SAN FRANCISCO PLANNING DEPARTMENT

Memo to the Planning Commission

Date:	February 5, 2015
Case No.:	2013.1522DV
Project Address:	24 Ord Court
Permit Application:	2013.1021.9830
Zoning:	RH-2 (Residential House, Two-Family)
	40-X Height and Bulk District
Block/Lot:	2619/066
Project Sponsor:	Aidin Massoudi
	Sia Consulting Corp.
	1256 Howard Street
	San Francisco, CA 94103
Staff Contact:	Tina Chang – (415) 575-9197
	tina.chang@sfgov.org
Recommendation:	Do Not Take DR and Approve Project with Modifications as Proposed

Re: 22/24 Ord Court Continued Discretionary Review Hearing, February 5, 2015

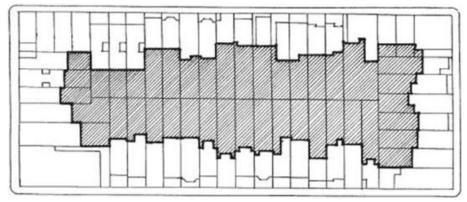
A. Condition 2A: Limit encroachment into the required rear yard to no more than 7.5' Project sponsor contentions that the value of the existing sloped back yards may only be realized by constructing at the top of the lots contradict conforming neighbors with similar sloped back yards who have landscaped or terraced the back yards to provide significant enjoyment. See photos below:
